Update Date	Revision Type	Reference	Section Description	Description of Revision	New or Deletion
1/16/2026	L&D Vol. 1	101.3	Classification Used in ODOT Design Criteria	Updated Office of Systems Planning and Program Management to Office of Technical Services	
1/16/2026	L&D Vol. 1	105.5.1	Documentation Format	Updated Safety Analysis Guidelines link & updated Office of Program Management to Office of T.E.D.	
1/16/2026	L&D Vol. 1	106.1	General	Updated Office of Program Management to Office of T.E.D.	
1/16/2026	L&D Vol. 1	106.3	Data-Driven Safety Analysis	Updated Safety Analysis Guidelines link & updated Office of Program Management to Office of T.E.D.	
1/16/2026	L&D Vol. 1	106.4	Data-Driven Safety Analysis Documentation	Modified language on when safety should be considered for projects. Updated Safety Analysis Guidelines link & updated Office of Program Management to Office of T.E.D.	
1/16/2026	L&D Vol. 1	Figure 107-1	Non-Complex Project Flowchart	Deleted because this figure is managed by Safety and posted to their website	Deletion

101.3 Classification Used in ODOT Design Criteria

Notes for Figure 401-11 - Double Left Turn Lanes

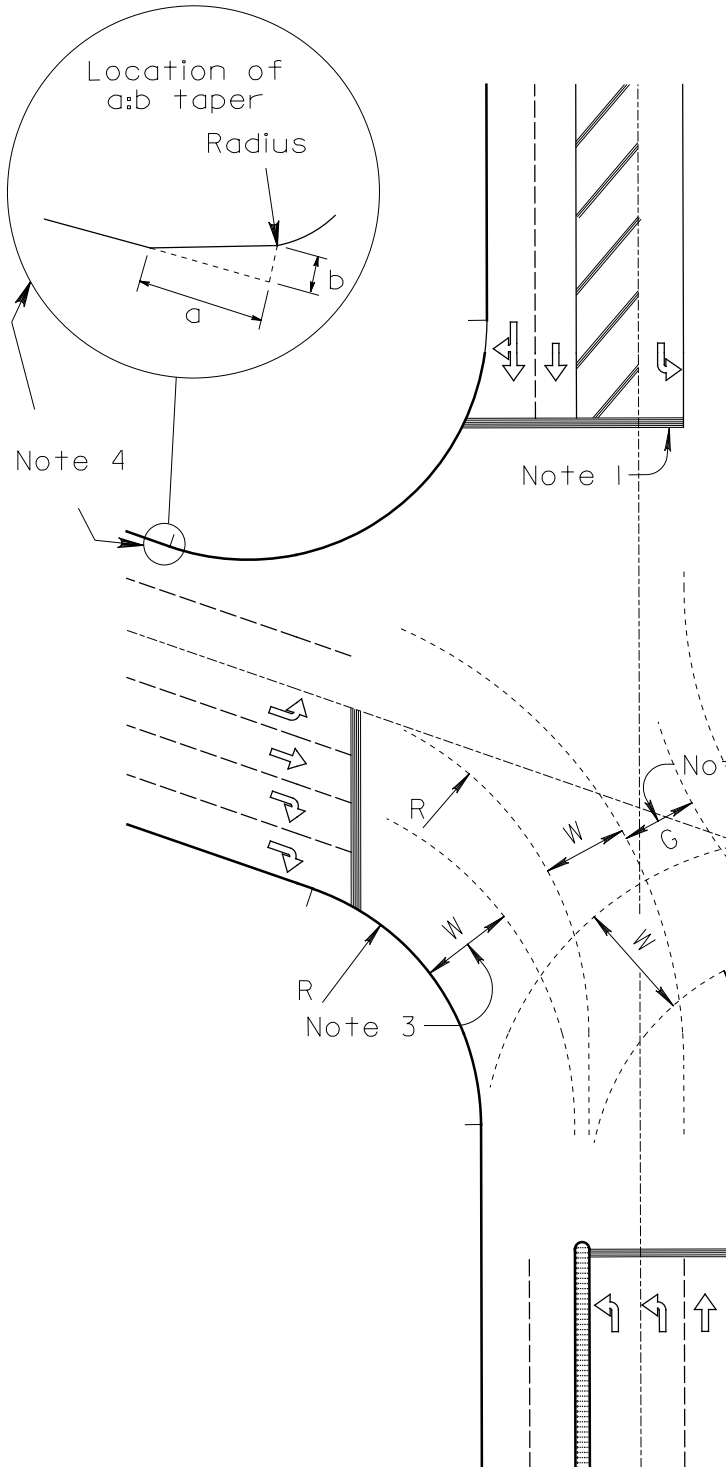
1/16/2026	L&D Vol. 1	Figure 107-2	Complex Projects Assessment with Alternatives Analysis without Safety	Deleted because this figure is managed by Safety and posted to their website	Deletion
1/16/2026	L&D Vol. 1	Figure 107-3	Complex Projects Assessment with Alternative Analysis with Safety	Deleted because this figure is managed by Safety and posted to their website	Deletion
1/16/2026	L&D Vol. 1	Figure 202-2	Maximum Degree of Curve	Corrected errors	
1/16/2026	L&D Vol. 1	Figure 202-5	Methods of Superelevation Rotation	Corrected print-error (letter A was missing in multiple locations)	
1/16/2026	L&D Vol. 1	305.2	Types and Uses	Added Type 11 curb	
1/16/2026	L&D Vol. 1	307.6.4	Adjacent to Noise Sensitive Areas	Revised Noise Wall contact to Statewide Noise Wall Coordinator	
1/16/2026	L&D Vol. 1	401.3	Crossroad Alignment	Added guidance for curves approaching a stop-controlled intersection	
1/16/2026	L&D Vol. 1	Figure 401-11	Double Left Turn Lanes	Corrected Green Book sheet reference in note 2

2. Opposing turning paths should always be checked to verify that there is no conflict (see dimension "G"). Per AASHTO "Green Book", [page 9-115](#), dimension "G" should be a minimum of 10'.

Length of Need at a Large Culvert

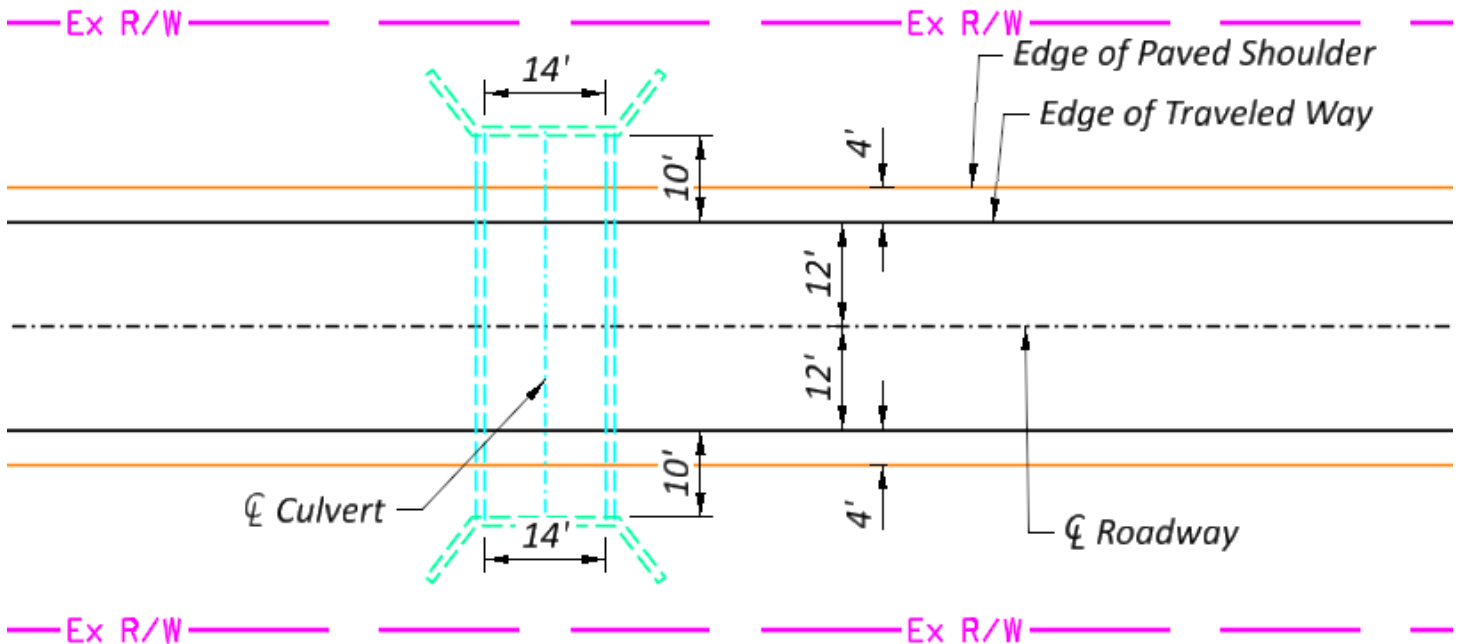
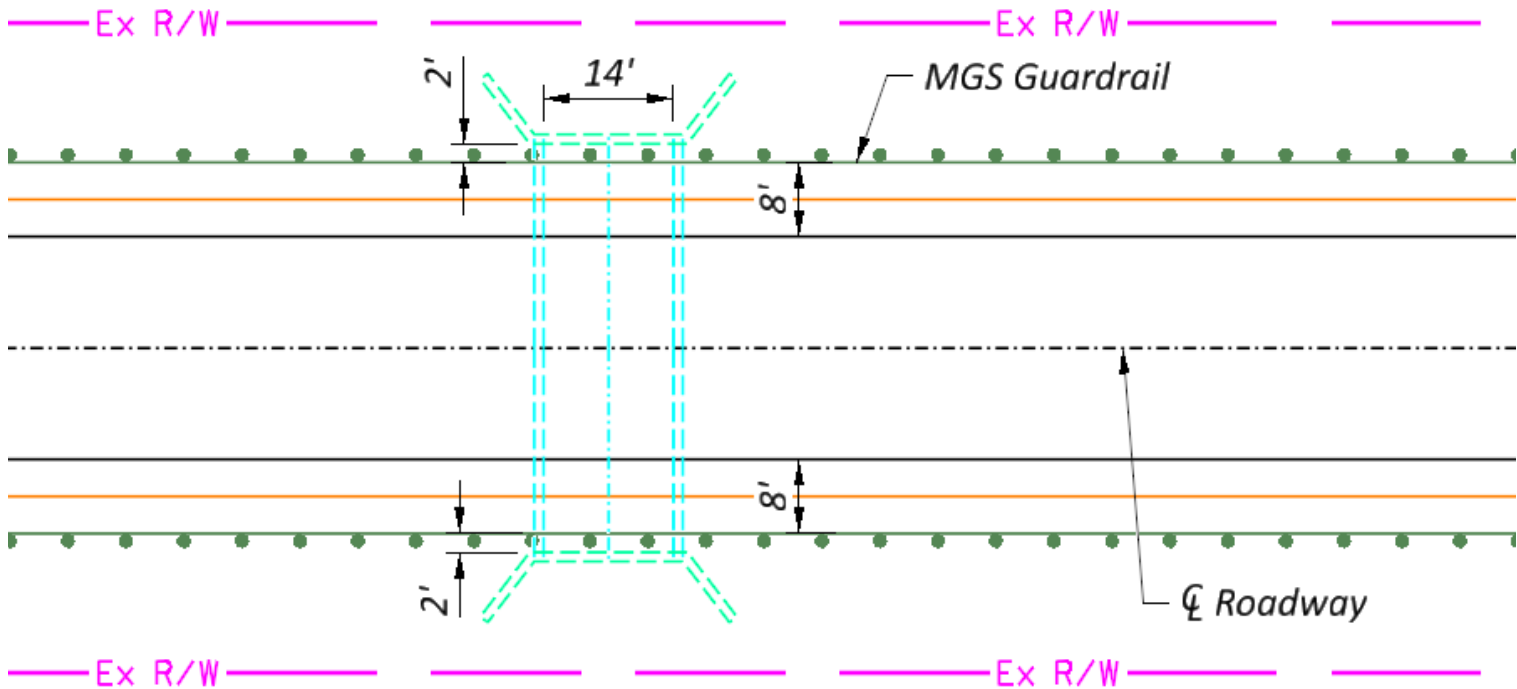
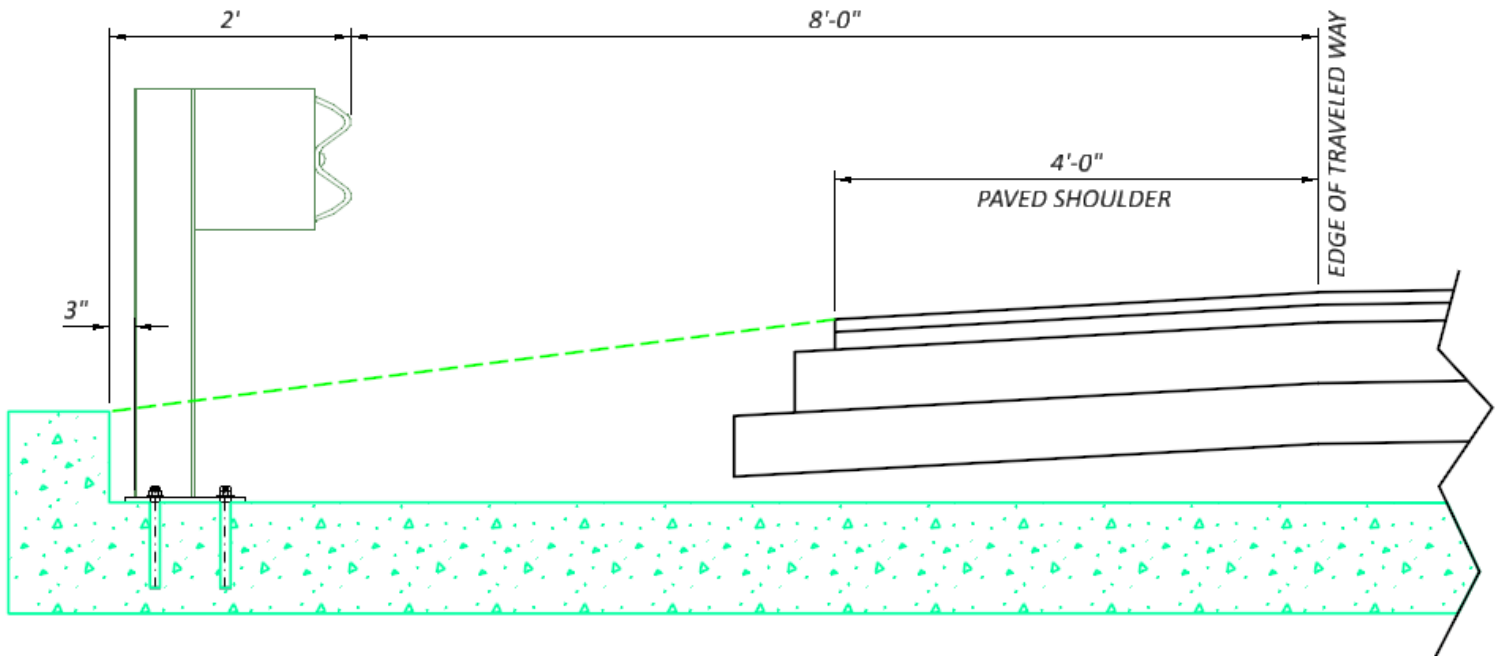
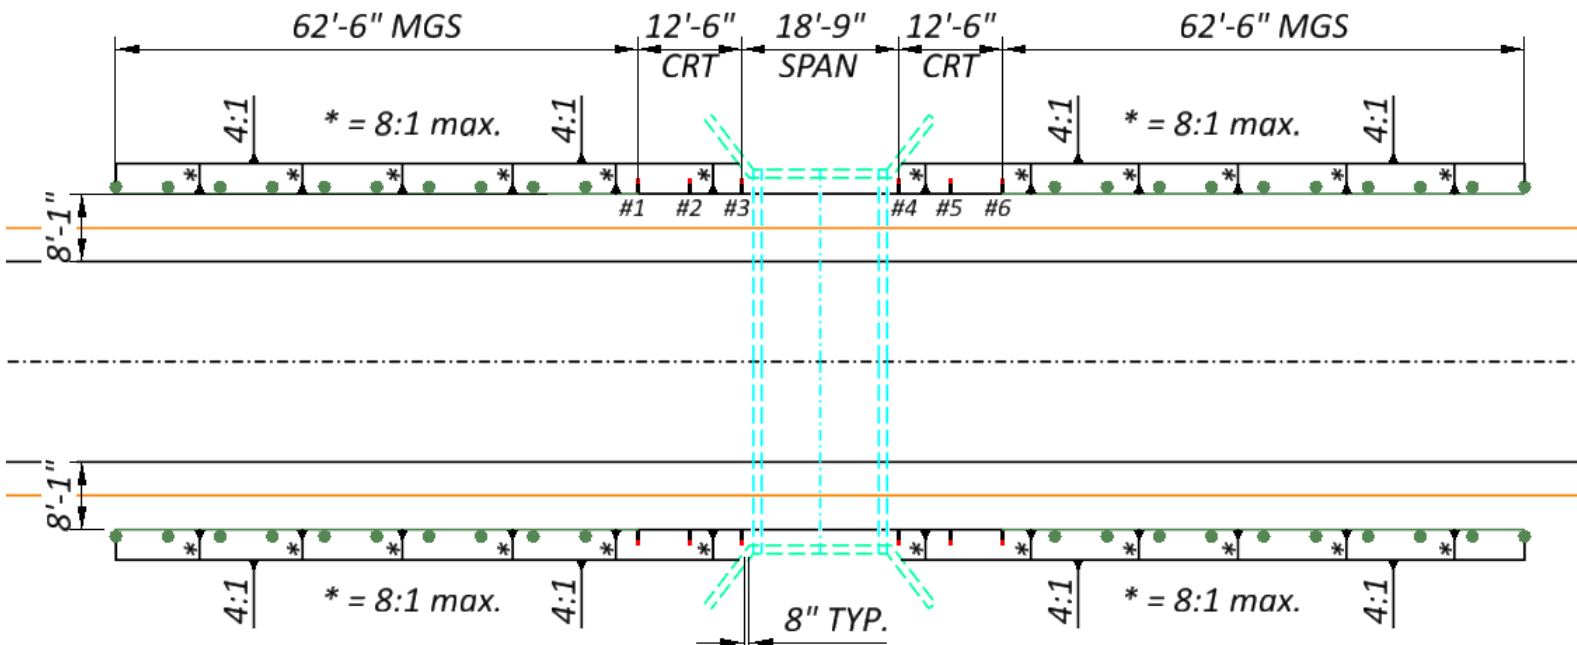
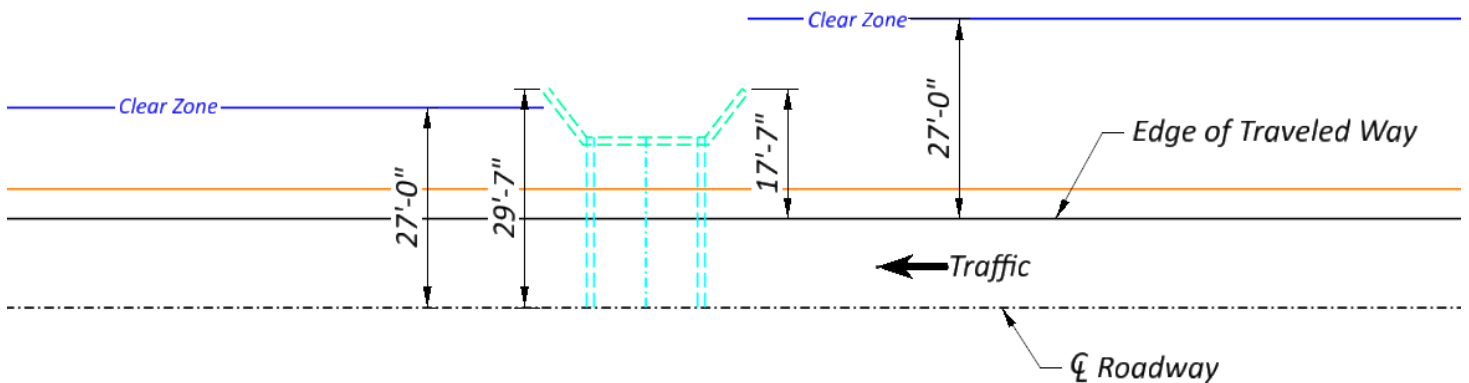
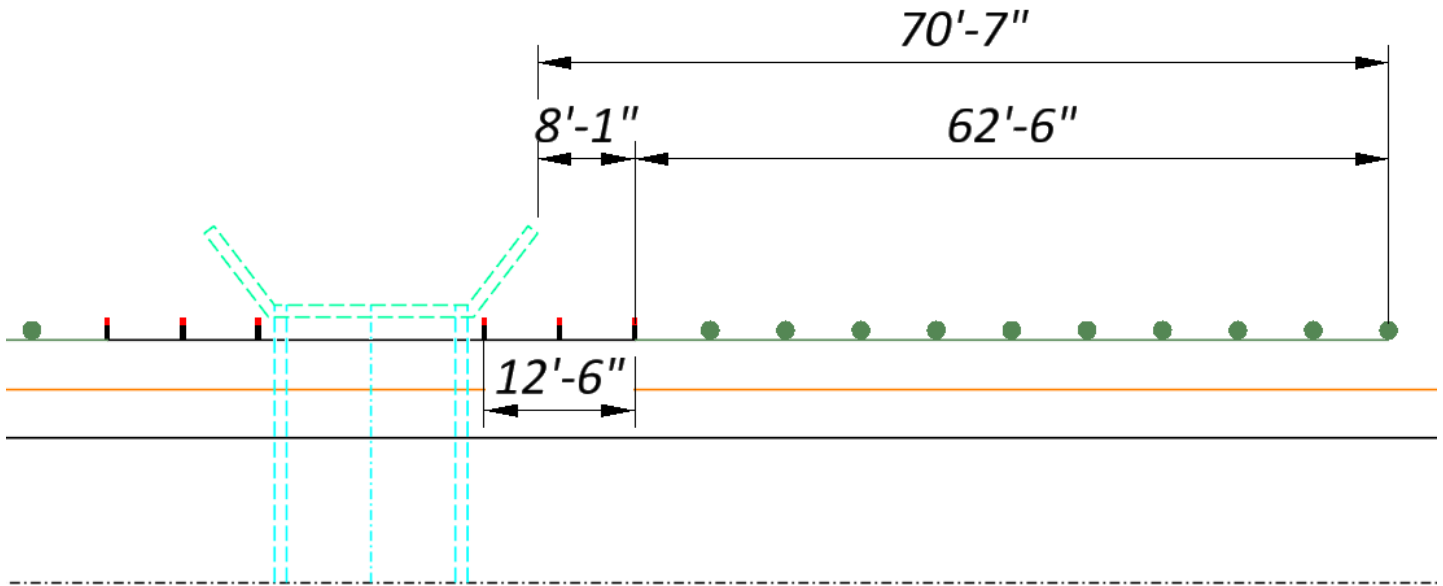
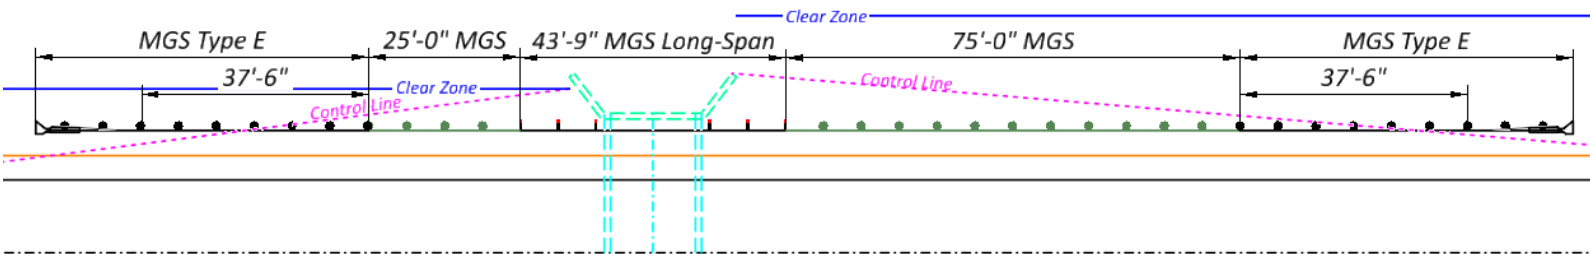
1/16/2026	L&D Vol. 1	Example 602-2	Length of Need at a Large Culvert	Completely new version of this sample problem using modern standards	
1/16/2026	L&D Vol. 1	Example 602-4	Barrier on the Outside of a Curve	Revised calculations and improved graphic readability	
1/16/2026	L&D Vol. 1	1002.2	HSM for Evaluation	Updated Safety Analysis Guidelines link & updated Office of Program Management to Office of T.E.D.	
1/16/2026	L&D Vol. 1	Plan Note R112a	ITEM 606 – ANCHOR ASSEMBLY, MGS TYPE B	Updated designer notes for system length, LON, and offset guidance due to new device (4F-T)	
1/16/2026	L&D Vol. 1	Plan Note R113a	ITEM 606 – ANCHOR ASSEMBLY, MGS TYPE E	Fixed typo	
1/16/2026	L&D Vol. 1	Plan Note R116	MGS GUARDRAIL INSTALLED IN ASPHALT	Revised asphalt item, allowable depth to 2", and other minor edits in conjunction with new detail added to MGS-2.1	
1/16/2026	L&D Vol. 1	Plan Note R127	CABLE BARRIER	Corrected title and item Special references.
